HORSHAM DISTRICT COUNCIL CONSULTATION

TO:	Horsham District Council – Planning Dept
LOCATION:	Rascalls Farm Shipley Road Southwater Horsham
DESCRIPTION:	Application for Approval of Details Reserved by Condition 4 to approved application DC/24/0249.
REFERENCE:	DISC/26/0173
RE-CONSULTATION:	1 st set of comments in black 2 nd set of comments in blue
RECOMMENDATION:	Modification
SUMMARY OF COMMENTS & RECOMMENDATION: 2nd set of comments Comments addressed, with thanks. However, minor modification is requested in regard to a potential area of conflict. 1st set of comments Modification is requested in order to recommend the discharge of Condition 4. Please see details below.	
MAIN COMMENTS: <u>Condition 4</u> <i>No development shall commence until full details of underground services, including locations, dimensions and depths of all service facilities and required ground excavations for that phase, have been submitted to and approved by the Local Planning Authority in writing. The submitted details shall show accordance with the landscaping proposals and Arboricultural Method Statement, complete with root barriers if needed. The development shall thereafter be carried out in accordance w

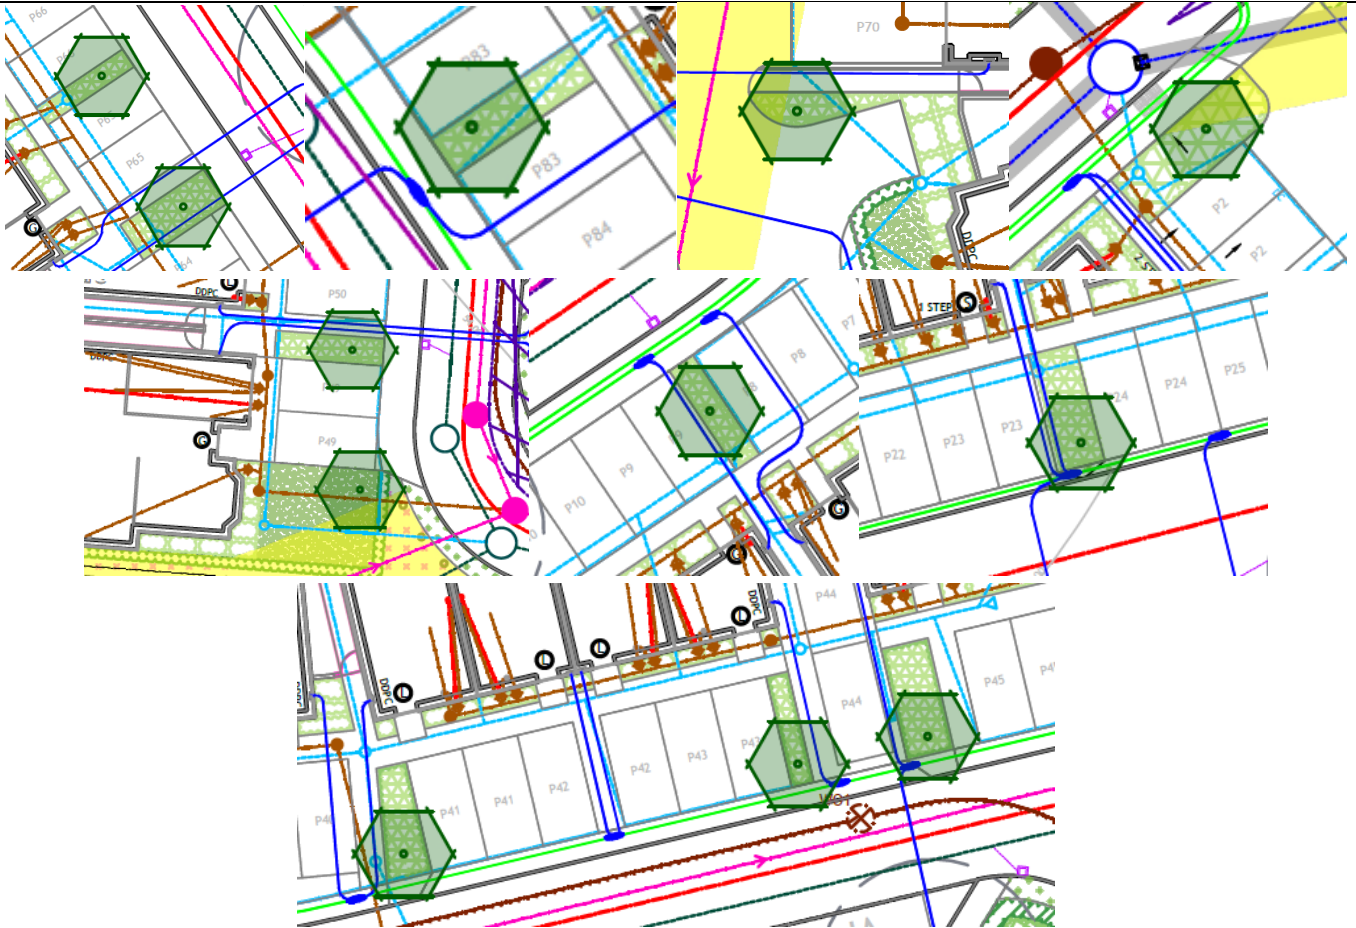
3. A utility run between the parking spaces of plot 83 (highlighted in yellow, below) demonstrates conflict with the tree pit and root cells. Please amend to avoid or relocate to a single trench.
